LHO As-Built 9/22/16

ISS Outer Loop	
Size	D
Doc#	DCDC Number: D1600298
Rev	Rev: 9-22-2016
Rev	Revision: 2

aLIGO ISS Outer Loop Back Board
D1600298-v2

Title Low Frequency Boost			
Size: A	DCC Number: D1600298		Ligo Project California Institute of Technology Massachusetts Institute of Technology
Drawn by: Ben Abbott	Date: 9/22/2016	Revision: v2	
File: C:\restored\Ben\ISS Outer Loop Back Board\Outer Loop Back Bd As Bld\mc21135158-RMch Sheet 2 of 10

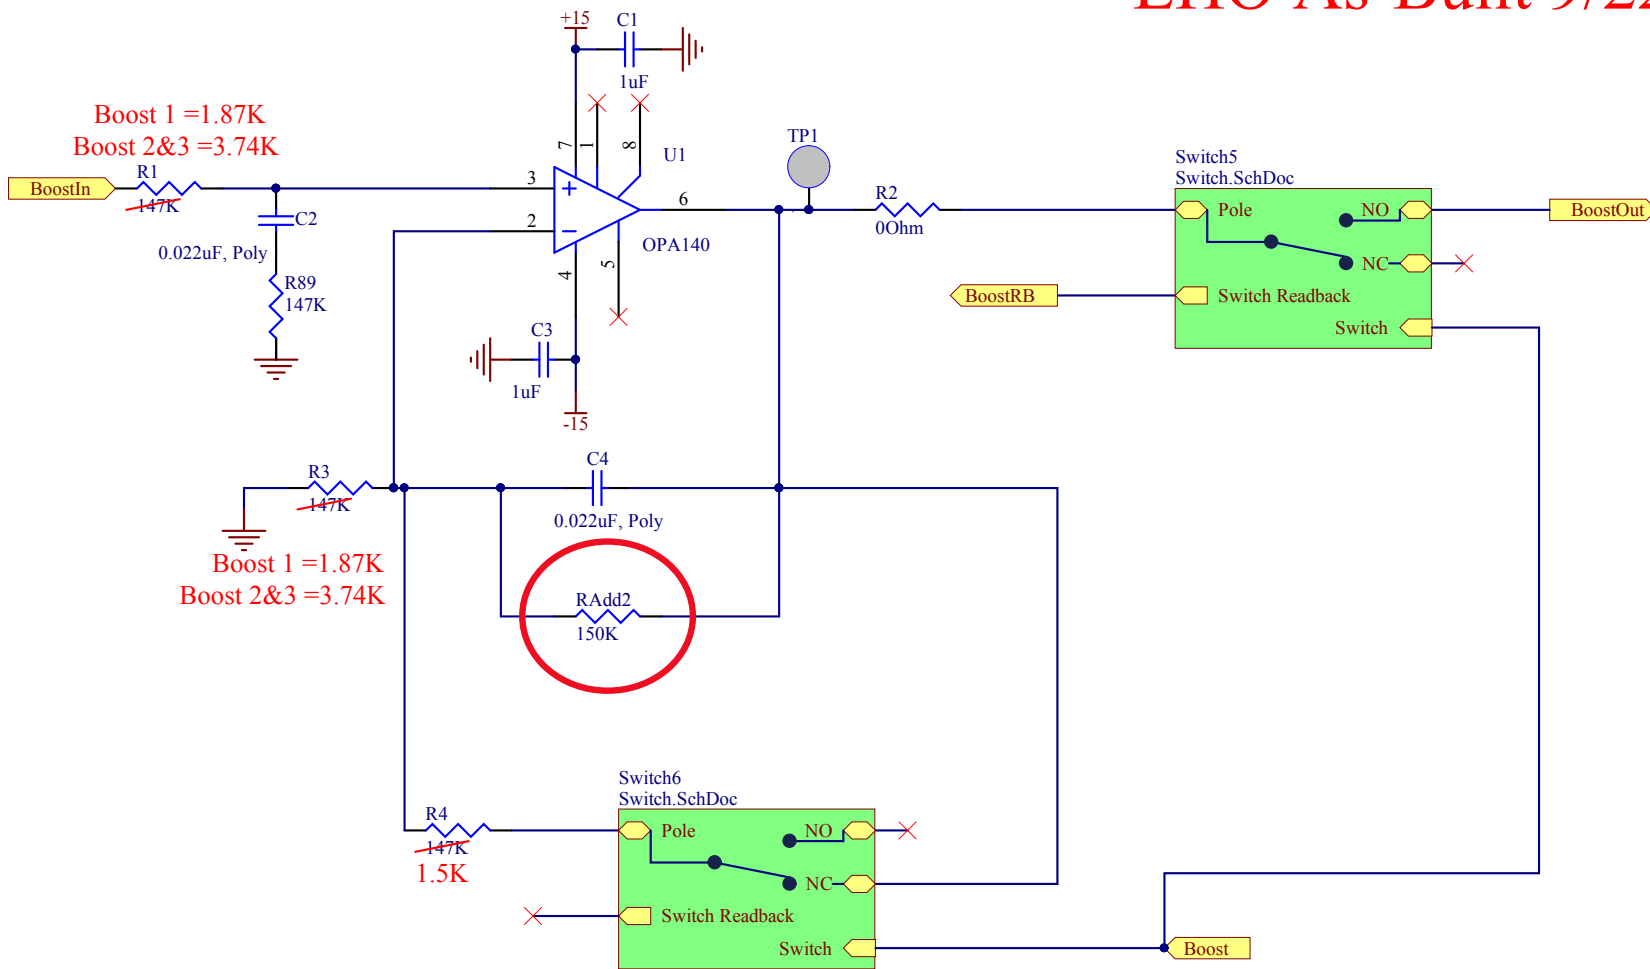
LHO As-Built 9/22/16

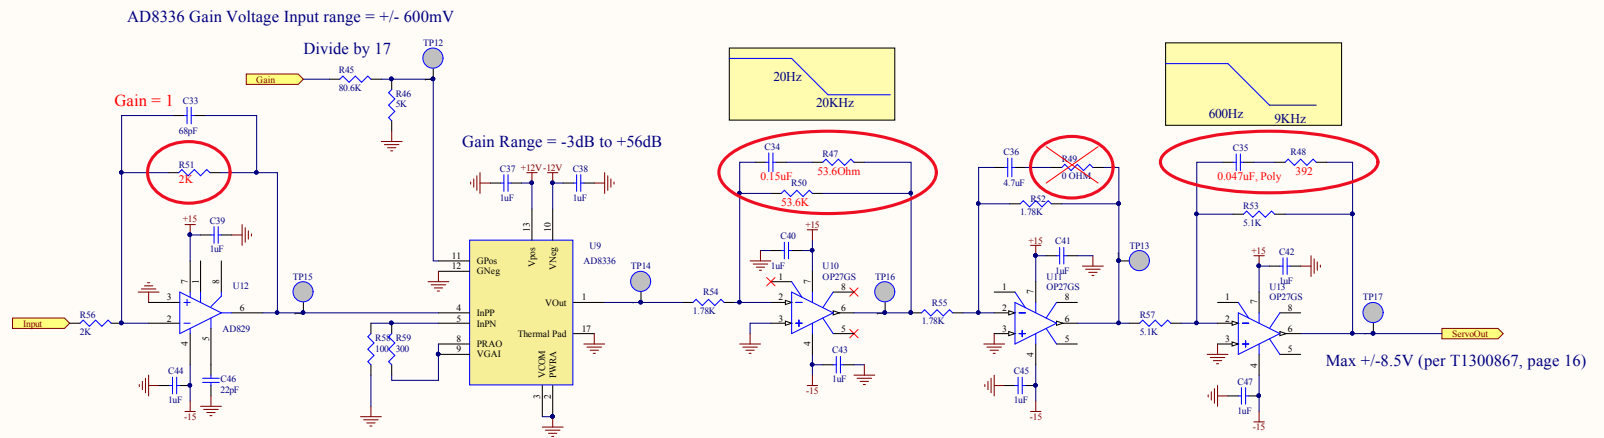
LHO As-Built 9/22/16

Title Whitening			
Size: A	DCC Number: D1600298		
Drawn by: Ben Abbott	Date: 9/22/2016	Revision: v2	Ligo Project California Institute of Technology Massachusetts Institute of Technology
File: C:\restored\Ben\ISS Outer Loop Back Board\OuterLoopBackBdAsBuilt\92216\Whitening_Sch09 of 10

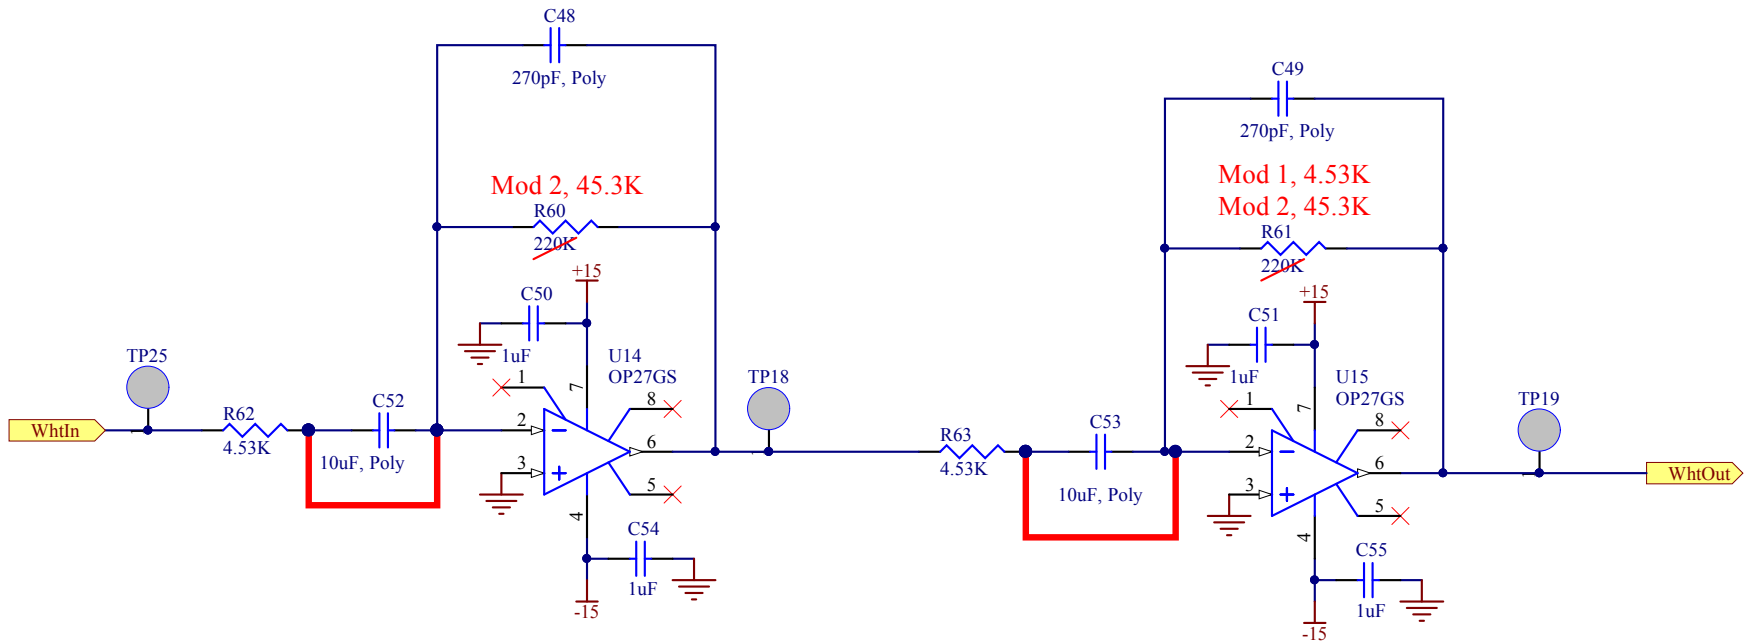
LHO As-Built 9/22/16
